Suncor Steepbank Mine  
application second  
request for supplemental  
information.

Re: Suncor Steepbank Mine Application  
Second Request for Supplemental Information  
Letter dated 1996-08-27

## POND 5 EAST CT SAMPLE SITES

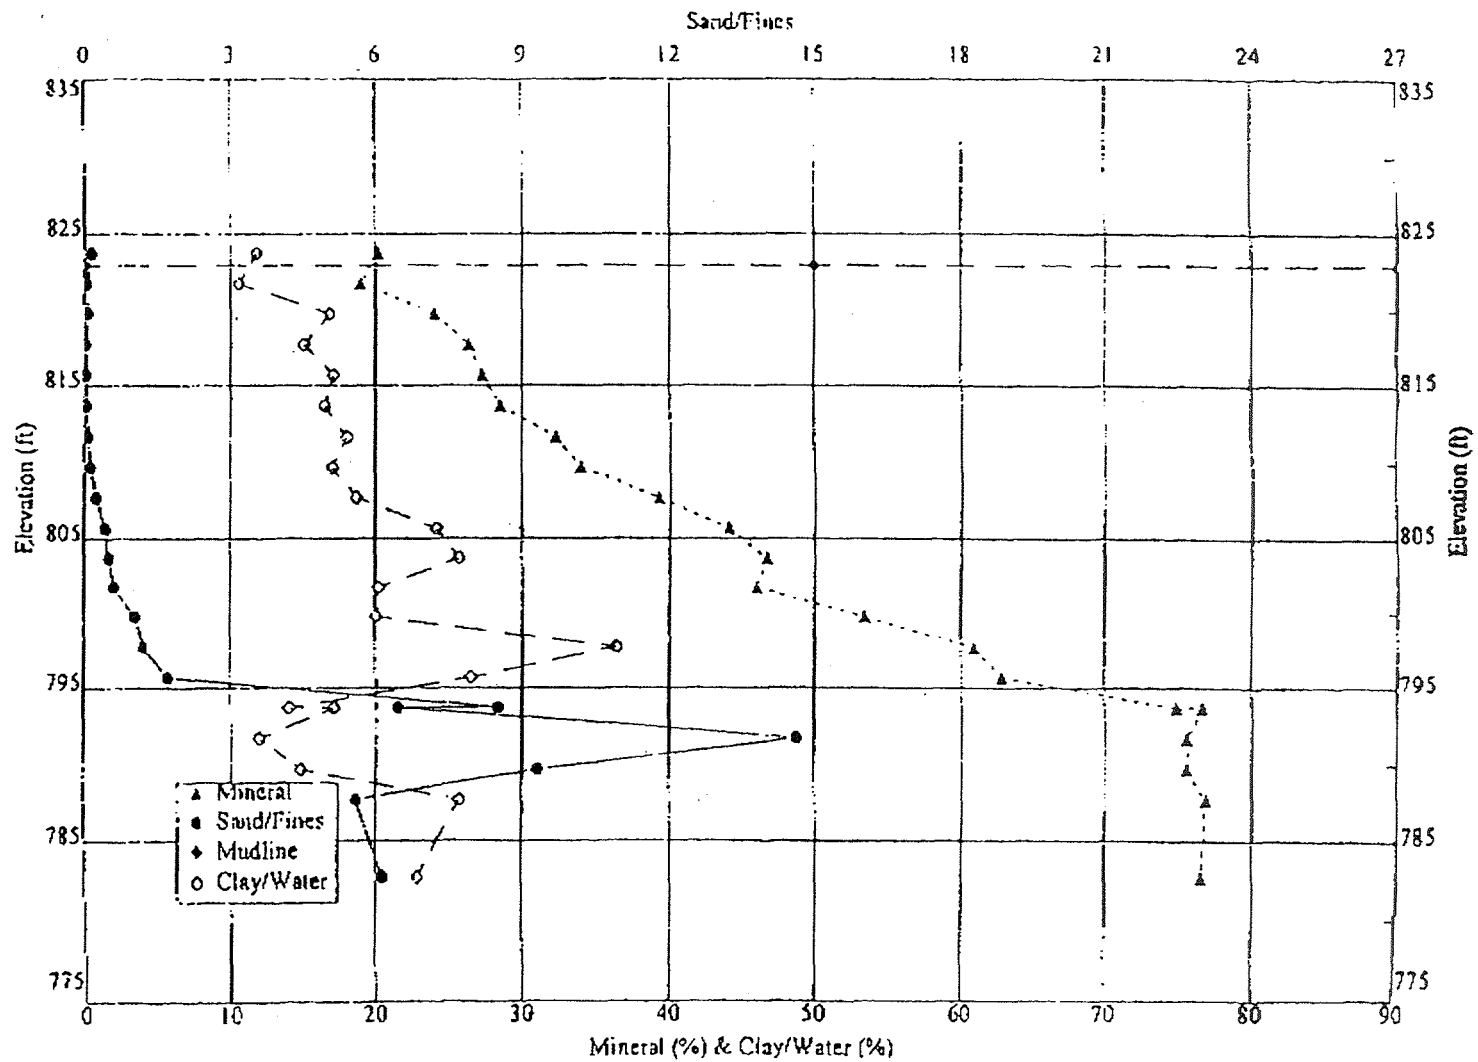
Figure 2-1 shows the sampling site location map in Pond 5E. Data for sites 6 and 11 are attached. These data indicate that the upper region of the profiles contain a low sand/fines ratio relative to the CT mixture of about 4.5 and the lower regions are enriched in sand. The conclusion is that there was some segregation in the deposit - ie. the sand was not retained in the CT mixture as per expectations. However, the data also show that clay as determined by the methylene blue test procedure is present within the lower regions of the deposit. The best estimate of fines capture rate in the lower region of the deposit is based on a comparison of the fines in the CT mixture and the fines in the upper region of the deposit. It is estimated that upper region contains 40% of the fines contained in CT when the CT process was operating according to specification. The capture rate in the lower region is the estimated to be 60%.

FIGURE 3-1 - OPTION 1 - RECLAMATION  
AS PER ORIGINAL SCHEDULE

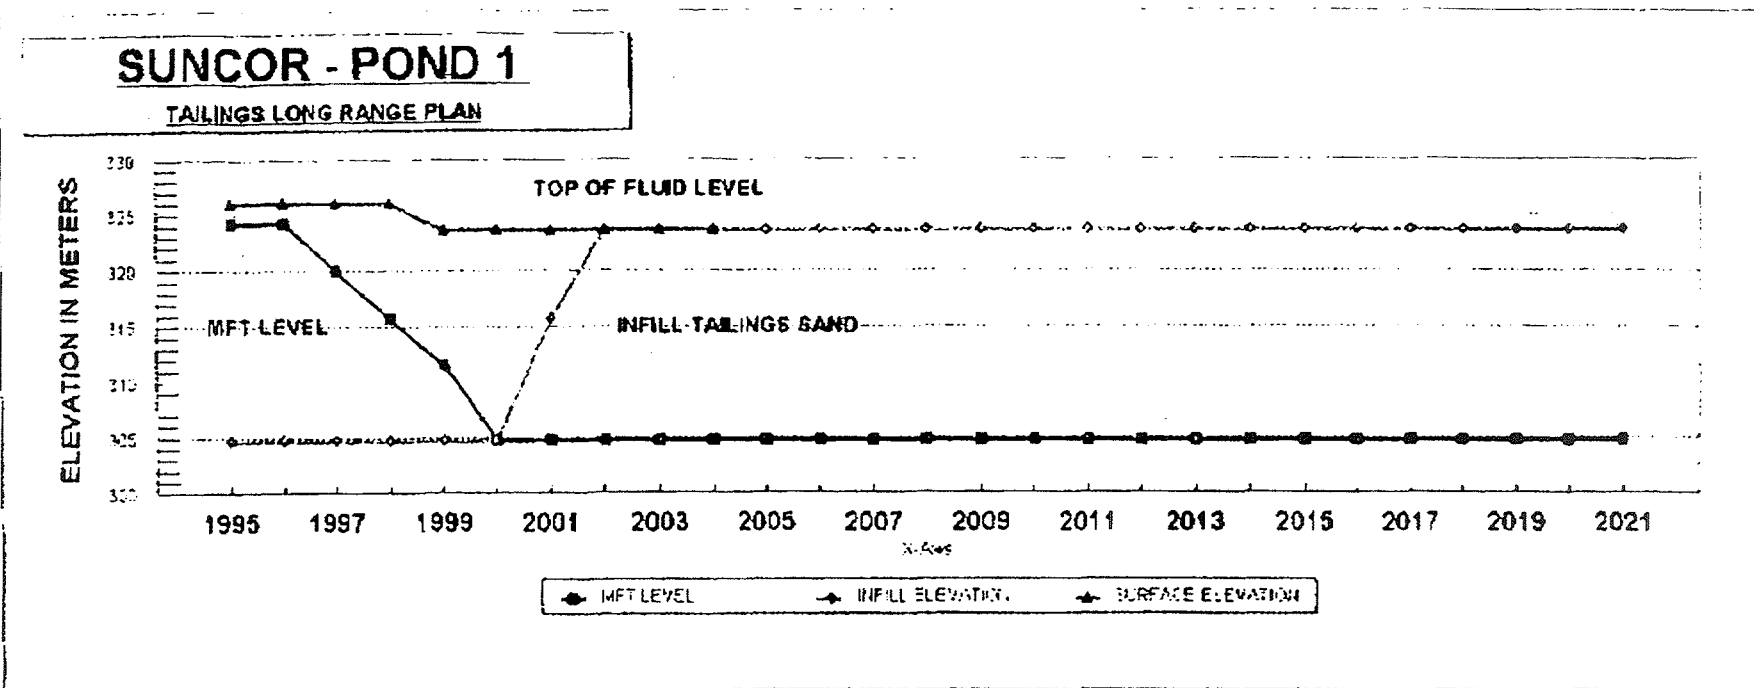
In Figure 3-1 note that the MFT level is drawn down very rapidly and all MFT is removed by the year 2000. All MFT removed would be sent to extraction and used to produce CT which would be pumped to Pond 5. Pond 1 is in-filled with sand by the year 2002, again very rapidly, and is then ready for final reclamation activities. This meets the original Pond 1 reclamation schedule.

FIGURE 3-2 - OPTION 1 - RECLAMATION  
AS PER ORIGINAL SCHEDULE

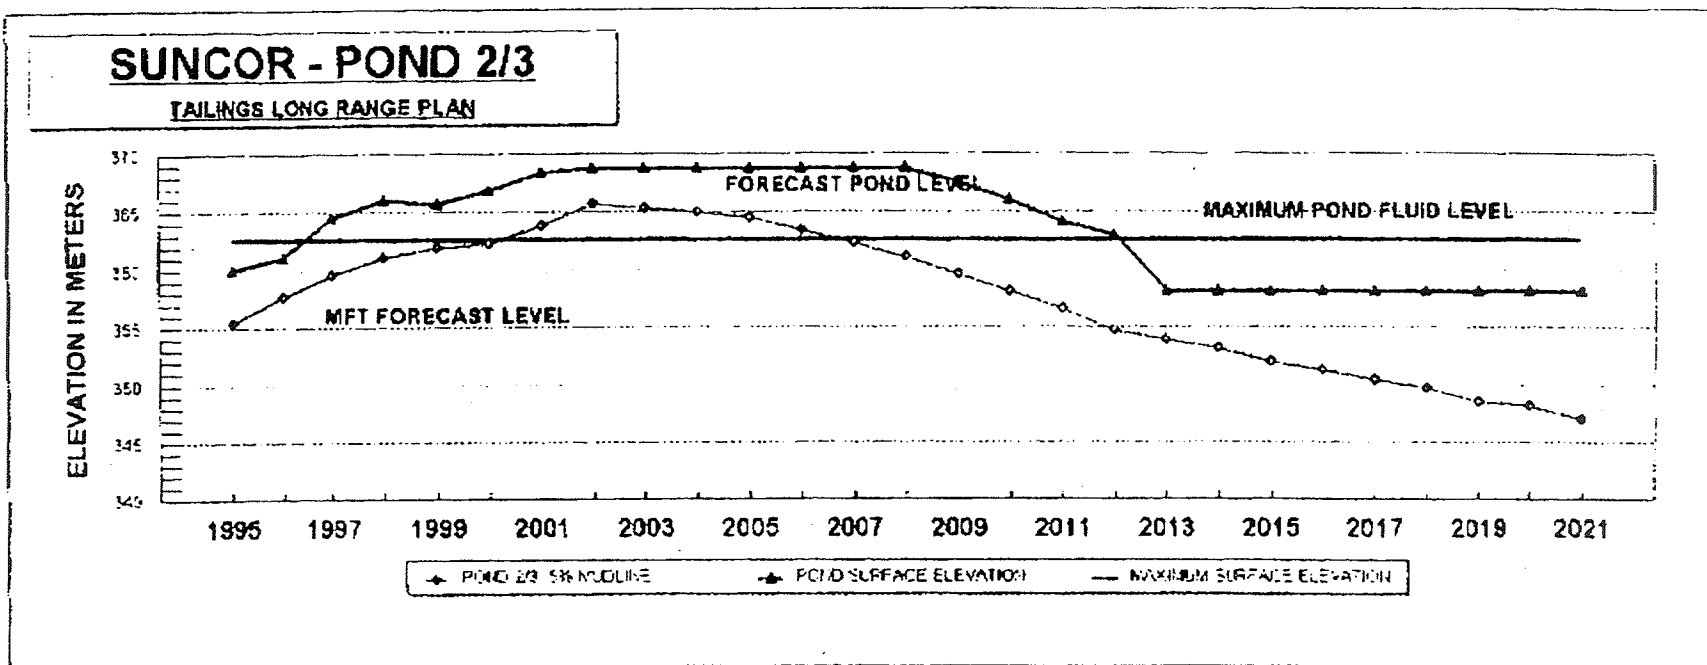
For CT to succeed fine tails are required at specific rates tied to sand production. If Pond 1 is made the priority the balance of fines for CT would come from Pond 2/3. However, if we do not remove enough fine tails from Pond 2/3 overtopping of the pond will occur, as can be seen in Figure 3-2. To maintain the level of Pond 2/3 at the maximum fluid level of 363 metres additional fine tailings would have to be transferred from Pond 2/3 to Pond 5. It is estimated that 35 million cubic metres of fine tails would have to be transferred starting in 1997.

FIGURE 3-3 - OPTION 1 - RECLAMATION  
AS PER ORIGINAL SCHEDULE

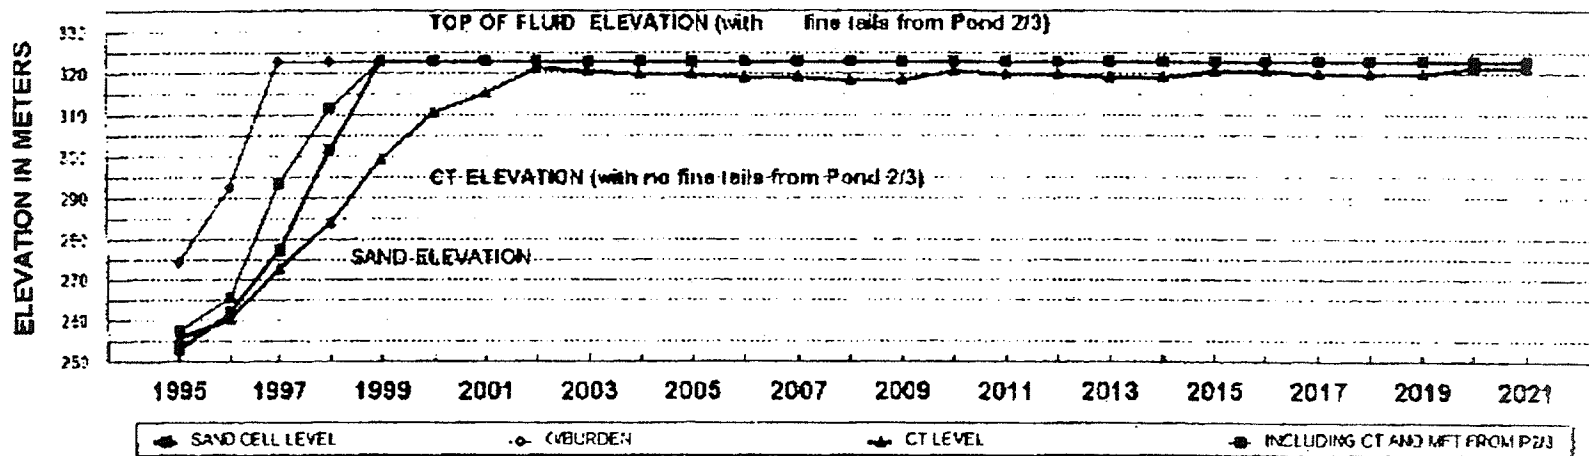
The transfer of fine tails from Pond 2/3 would have a significant impact on the quality of CT being placed into Pond 5 and the tailings plan overall. Figure 3-3 illustrates the changes in elevations of fluids in Pond 5. Impacts can be summarized as follows :

- Dyke construction may have to be accelerated, which would require more sand and overburden. We are short of both at present.
- The overall CT sand to fines ratio would go from a target of 4.0 to 3.0 or less.
- Consolidation of Pond 5 would be slowed considerably (20 % more fines would be going into the pond).
- The development of strength within the deposit to support a dry reclamation surface is seriously delayed. Strength depends on sand grain contact which only occurs after the fines are consolidated within the voids of the sand matrix. The more clay in the voids the longer time required to reach a significant strength.
- The release of water from Pond 5 is critical to the success of the CT plan and the placement of untreated fine tails into Pond 5 may contaminate the released water.
- Large slugs of fine tails could end up trapped in the CT, the released water or on the surface.

FIGURE 3-4

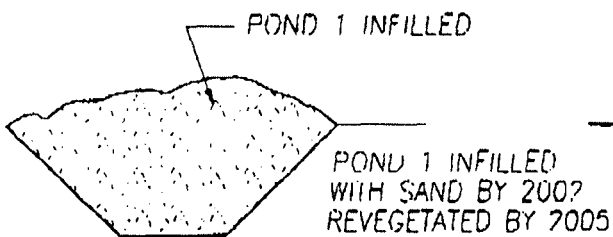
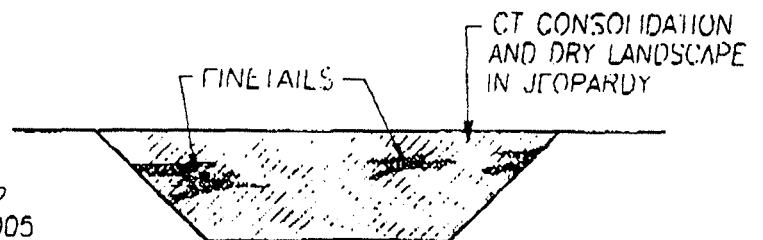
As illustrated in Figure 3-4, Pond 1 would be infilled by 2002 and reclaimed shortly after. Pond 5 would have some mixture of 3.0 to 4.0 sand to fines ratio CT, and Fine Tails and entrained bodies.

In summary Suncor would be jeopardizing the dry landscape reclamation of a 180 million cubic metre pond in order to accelerate the reclamation of a 23 million cubic metre pond. In essence Suncor believes that the dry reclamation landscape would not be achievable at a 3.0 to 1 (or less) sand to fines ratio, within the reclamation certification time frame.

FIGURE 3-5 - OPTION 2  
PRESENT OPERATIONAL PLAN

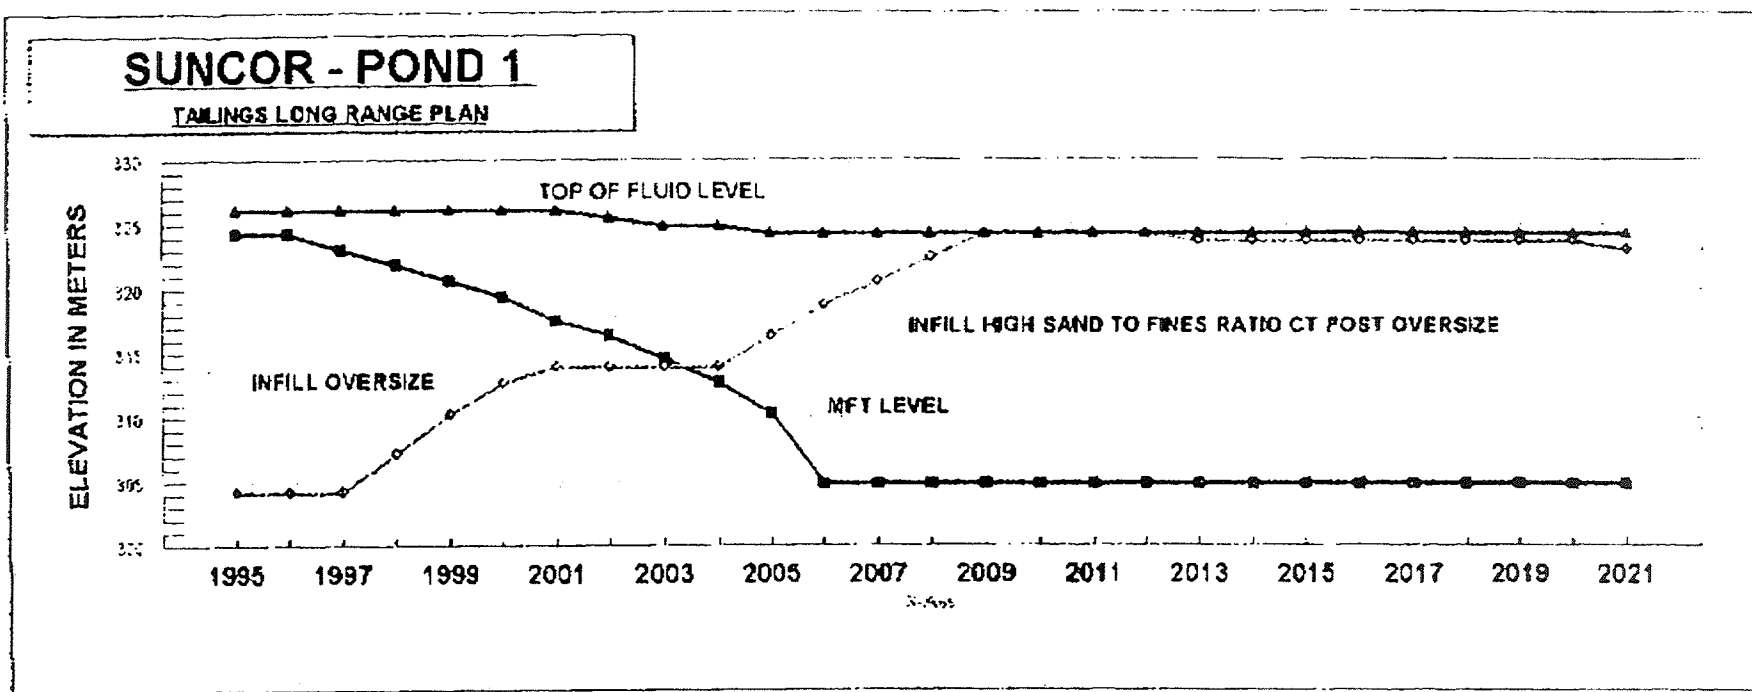
Figure 3-5 illustrates the draw down and reclamation of Pond 1. Although it is a slower drawdown than the original plan, it allows Suncor to keep Pond 2/3 in control and does not require any transfer of fine tails to Pond 5. The operation of Pond 5 is illustrated in Figure 3-6.

FIGURE 3-7 - OPTION 2  
PRESENT OPERATIONAL PLAN

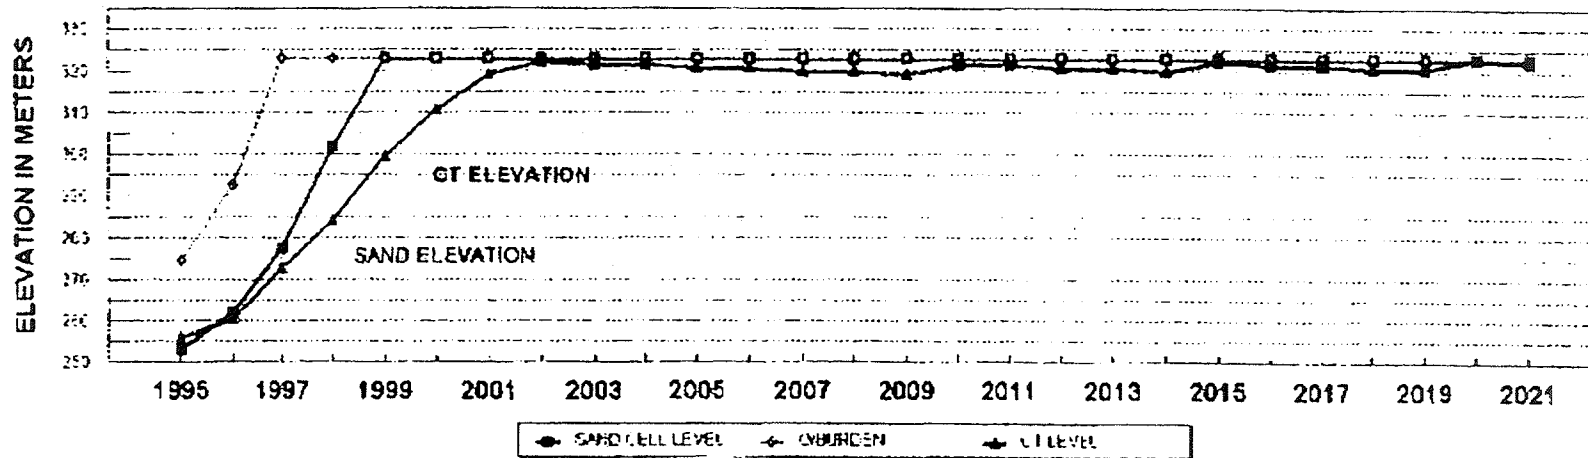
Figure 3-7 illustrates the steady controlled build-up of good quality CT in Pond 5, which should consolidate and produce a trafficable surface by 2020. Figure 3-8 illustrates the forecast outcome of this plan.
